**Service Bulletin**

**No.:** MZ07-US03 **Date:** March 8, 2007

Model: CC-4300

Subject: Grinding Noise

Fig. 2. Confirm a  $\frac{1}{2}$  mm space between the base of worm gear and Tray motor plate.

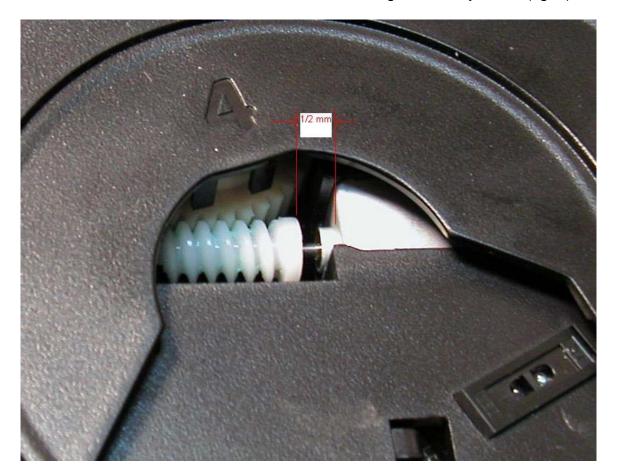
**Symptom:** After replacing the Tray motor and Worm Gear a grinding noise is heard when the tray rotates.

**Solution:** Adjust the worm gear on the Tray Motor. See the following for details.

Using a metric ruler or caliper adjust the worm gear to allow a distance of ½ mm from the base of the Worm Gear to the top plate of the Tray motor (fig. 2) or 3 cm from the base of the Worm Gear to the collar/bearing of the Tray motor (fig. 3).
